AGENDA

PLANNING AND ZONING COMMISSION

January 19, 2016 - Tuesday

**Figure 2
Removal Activity Map**

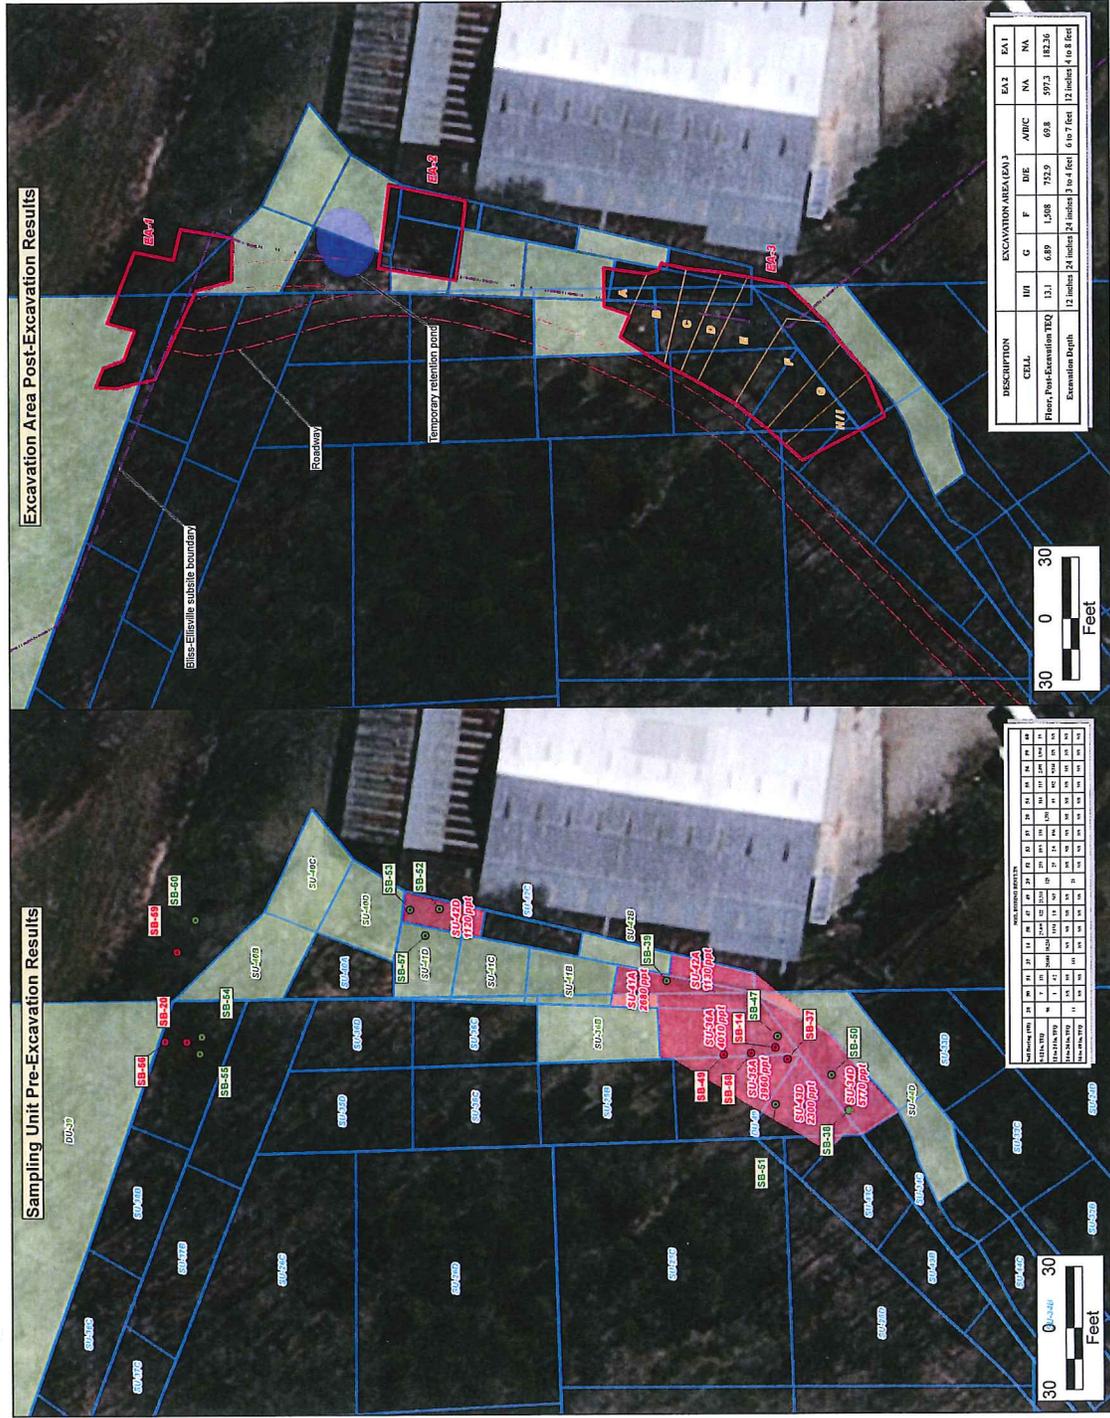
- g. Fig. 2 Pre-Excavation
 - i. Please add a triangle illustrating EA-1.
 - ii. Soil Boring table is illegible.
 - h. Fig. 2 Post-Excavation
 - i. Please illustrate NPL line in bright color.

- ii. Please add the 4 cell letters to EA-2.
 - iii. Please clarify EA-1 with Table 3 since it's an odd shape with 4 north walls.
 - i. Fig. 3
 - i. Please illustrate NPL line in bright color.

Sheet Title:
TREE PRESERVATION PLAN P-7

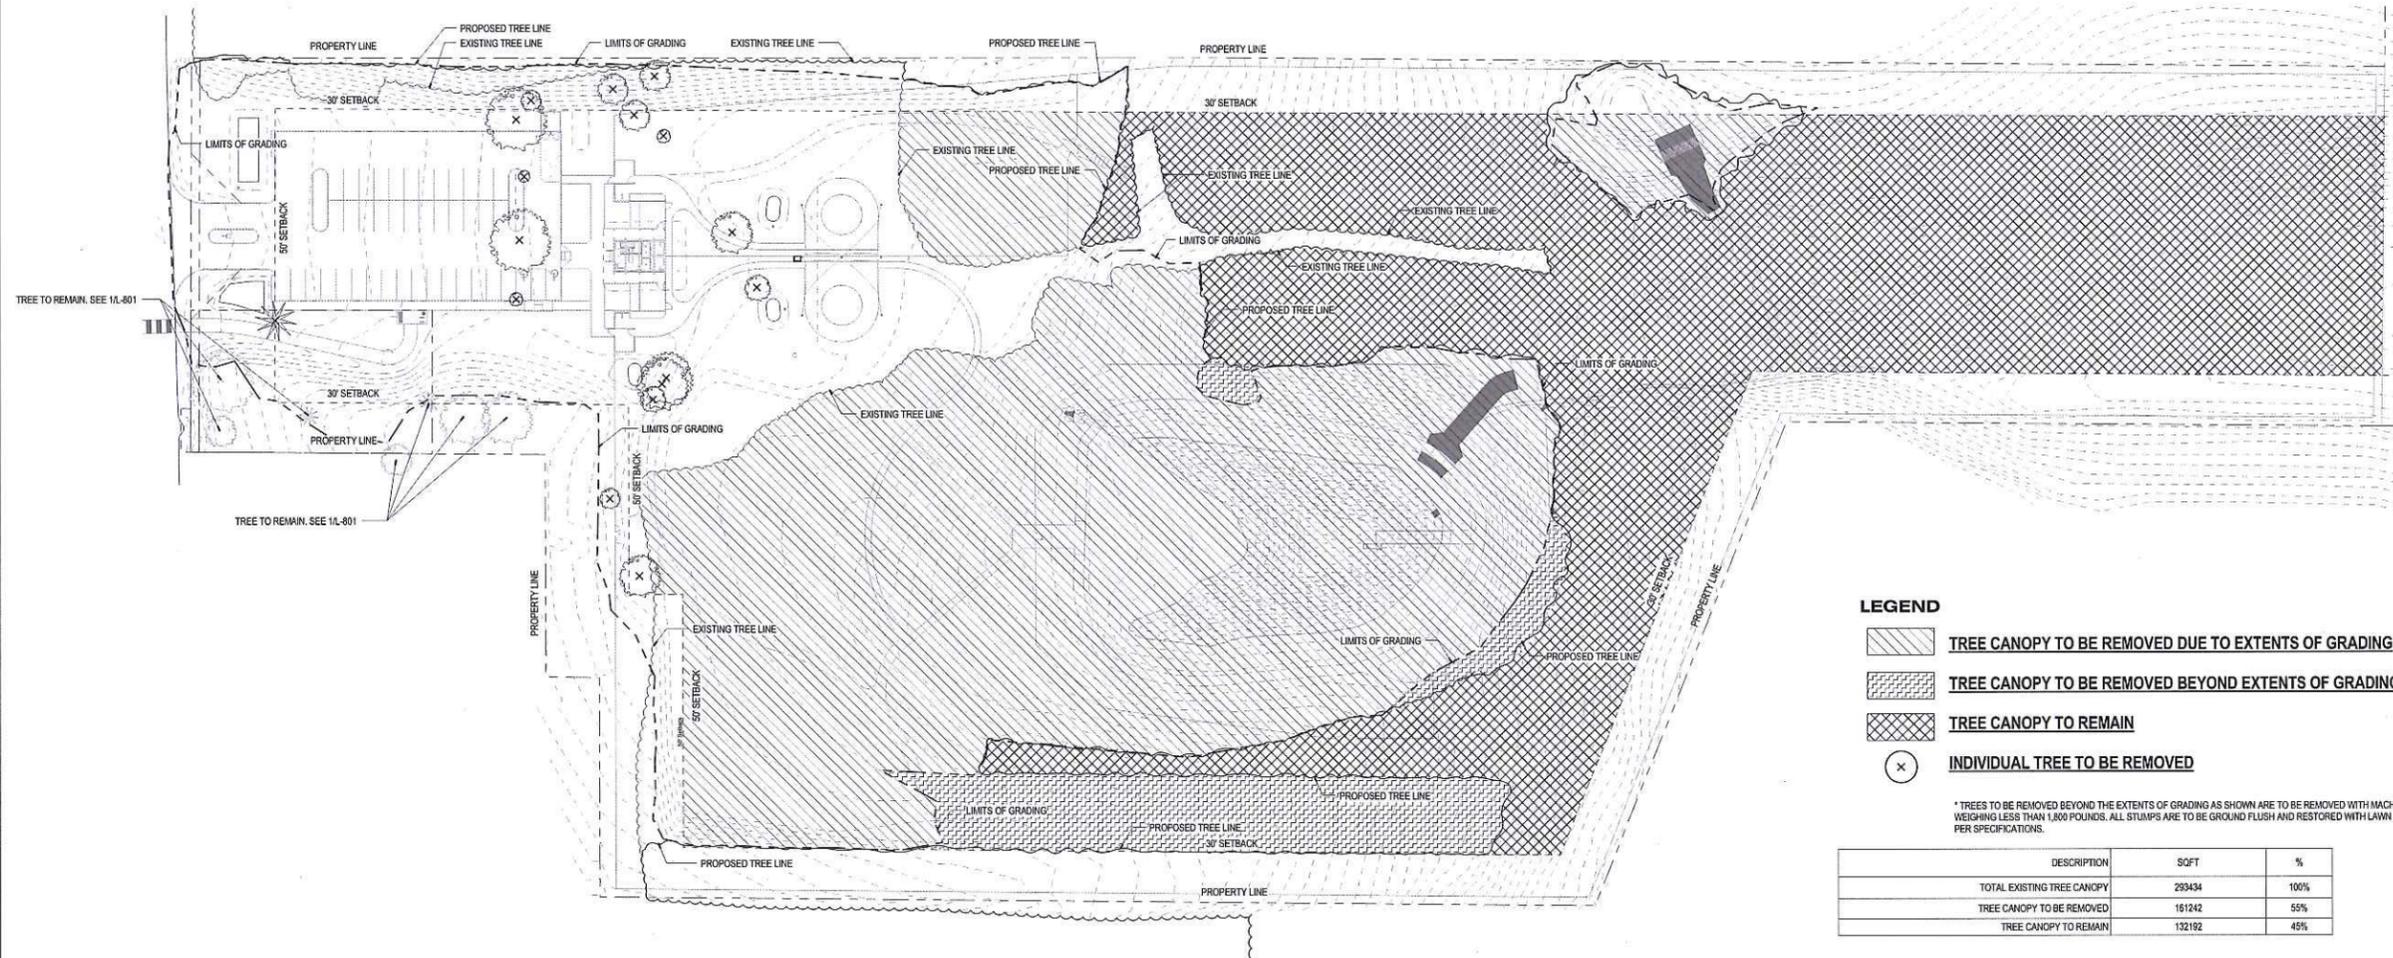
7. Please revise the tree clearing limits to reflect the current grading plan, as shown on Sheet 1 of 14.
